## Clarifications and updates to the Guidance

### ‘Repairing and rebuilding houses affected by the Canterbury earthquakes’

The following updates provide clarification and further information on technical issues relating to MBIE’s guidance ‘Repairing and rebuilding houses affected by the Canterbury earthquakes’. These issues result from new information or feedback received on the Guidance since its publication in December 2012.

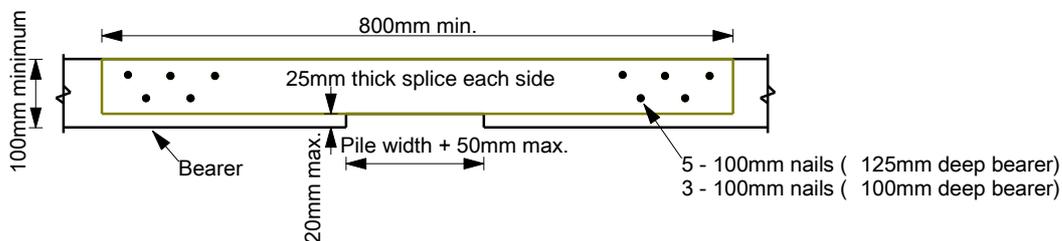
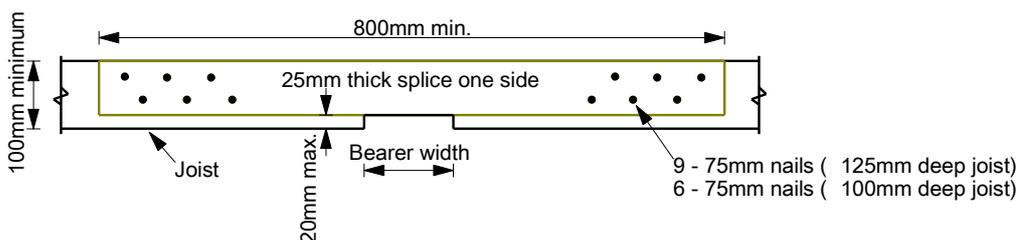
**43. Is it acceptable to notch bearers and piles beneath an existing Type A or Type B dwelling to assist with the relevening process?  
(Guidance document reference – Part A section 4.3, Part A appendix A1, Part C section 14.2)**

Yes it is acceptable to notch these elements, provided that they are notched within the limits detailed in this answer. It must be done as part of the floor relevening where some jacking and packing is undertaken and the final resulting floor is overall no lower than it was prior to the relevening process commencing. This ensures that Building Act section 112 is complied with in relation to Building Code Clause E1.

### Case 1: Ends of bearers

The ends of 100mm and 125mm deep bearers may be notched by 20mm with a square cut transition. If the transition is sloped at 2 to 1 then the notch depth may be increased to 35mm. The remaining capacity of the bearer is adequate to take normal design floor loadings of 1.5kPa. On some occasions, engineers have chosen to use a steel shoe adjacent to the notch for added strength.

### Case 2: Intermediate supports of bearers

Where bearers span over intermediate supports, they may be notched on the underside (compression) face of the bearer by 20mm over a maximum length equivalent to the pile width plus 50mm. 800mm long by 25mm thick side splice plates must be added, fixed at each end (5 - 100mm nails for 125mm deep bearer and 3 - 100mm nails for 100mm deep bearer). In this case, removal of some of the bearer depth will reduce the bending strength and stiffness. It is therefore necessary to add splice members to the sides of the bearer to recover the original bending strength at the notch. It is important that the splice elements also bear on the top of the pile for the splice to be effective.

**Case 3: Ends of Joists**

The ends of 100mm and 125mm deep joists may be notched by up to 20mm with a square cut transition. If the transition is sloped at 2 to 1 then the notch depth may be increased to 30mm. It is not necessary to add a metal shoe to the joists. Notching the ends of joists is similar to the ends of bearers except that the loads at the notch are less. Most joists in Type B floors are 125mm deep but there will be instances where they are 100mm deep. The above limits may be applied to joists deeper than 125 mm. Specific designs may allow deeper notches in these sizes.

**Case 4: Intermediate support of joists**

At intermediate supports, 100mm and 125mm deep joists may be notched up to 20mm with a square cut transition. An 800mm long by 25mm thick side splice is required to be fixed to each joist at the notched crossing (9 – 75mm nails each end for 125mm deep joist and 6 – 75mm nails each end for 100mm deep joist). In this case, removal of some of the joist depth will reduce the bending strength and stiffness. It is therefore necessary to add splice members to the sides of the joist to recover the original negative bending strength at the notch. It is important that the splice elements also bear on the top of the bearer for the splice to be effective.

Cross section - Type 2A

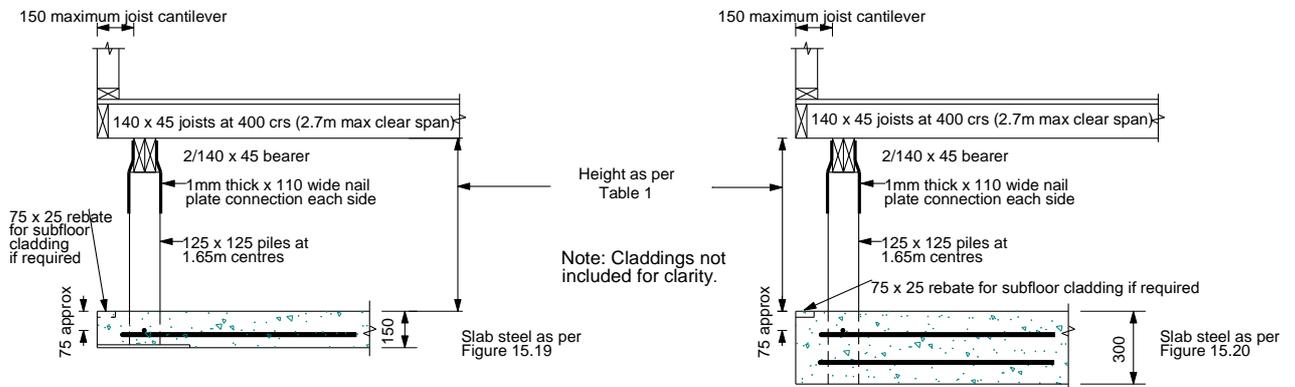
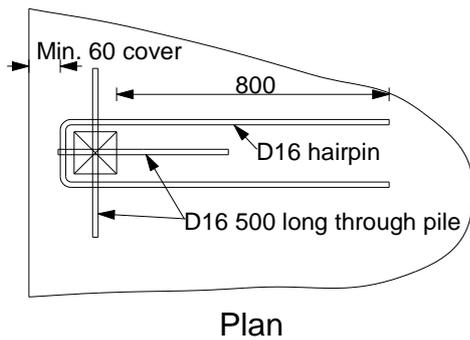
**45. For TC3 Type 2A and 2B surface structure foundations, are there alternative ways of finishing the perimeter of the slab and perimeter subfloor cladding?  
(Guidance document reference – Part C, Section 15)**

Consideration has been given to providing another detail that has the edge of the slab in the same vertical plane as the cladding line above, and enables the slab to be cast at a level slightly above the surrounding ground level.

The TC3 Type 2A and 2B foundation options were developed on the principle that the timber piles cantilevered from the slab, thus providing the lateral support for the superstructure under wind and earthquake loading. All piles are expected to introduce a bending action to the slab under lateral loading.

Figures 15.19 to 15.21 of the Guidance indicate that the slab should extend 500mm beyond the exterior row of piles. If the joists and bearers are cantilevered beyond the bearer or the last pile in the row respectively, then it is possible to cover most of the extension. However, it has been determined that a reduction in the joist size to 140 x 45mm and a change in the bearer size to 2/140 x 45mm members is a more economic option for these structures. This means that the span (a maximum 2.7m clear span when at 400mm centres) is less than a 190 x 45mm joist can span and extra rows of piles will be required. It also means that the overhang of the joist on the bearer (the cantilever) may only be 150mm. This is suitable for both single and two storey houses with light roofs and either light or medium weight wall cladding.

Water should not be allowed to pond beneath the floor of the completed dwelling. Therefore, the ground level under the house (Type 2A) and the top surface of the slab (Type 2B) should be set at a level that is higher (approximately 50mm) than the surrounding land.

The new details for the Type 2A and Type 2B under-slab in TC3 have been developed as shown in the following figures. These details should be read in conjunction with Figures 15.19 to 15.21 of the Guidance.

**Figure 1: TC3 Type 2A-150 Foundation**

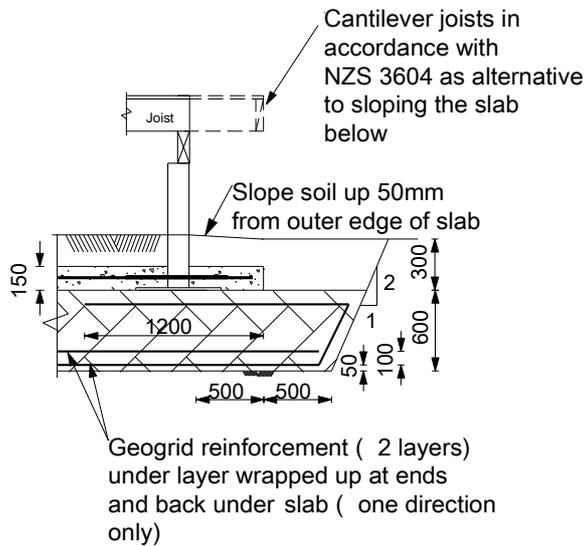
**46. There have been some changes to the descriptions of the TC3 Type 2 surface structure foundations in the Guidance. Can you please provide a summary of the available Types and their specifications?  
(Guidance document reference – Part C section 15.3)**

The Guidance provides details for a Type 2A and a Type 2B surface structure foundation. The Type 2A has a 150mm concrete under-slab and the Type 2B has a 300mm under-slab. Both had a 600mm reinforced gravel layer included beneath the slab. Q&A # 38 extended the guidance for Type 2A to allow, as an alternative, a 300mm slab to be used in the better areas of TC3 (where the SLS settlements were <100mm) without the need for a 600mm reinforced gravel layer.

For greater clarity, the Type 2 surface structure systems have been re-named as follows:

Identifier	Description	Maximum calculated SLS settlement (mm)
Type 2A-150 (refer to Figure 1)	A 150mm concrete under-slab in combination with a 600mm reinforced gravel layer (refer to Figure 15.19)	100mm
Type 2A-300 (refer to Figure 2)	A 300mm concrete under-slab, reinforced as per type 2b slab over a 150mm layer of compacted well graded sandy gravels extending 500mm beyond the edge of the slab and with a geotextile layer under the compacted gravel. The geotextile layer is to be turned up at the ends of the gravel layer and returned a minimum of 1m under the slab.	100mm
Type 2B-300 (refer to Figure 3)	A 300mm concrete under-slab in combination with a 600mm reinforced gravel layer (refer to Figure 15.20)	200mm
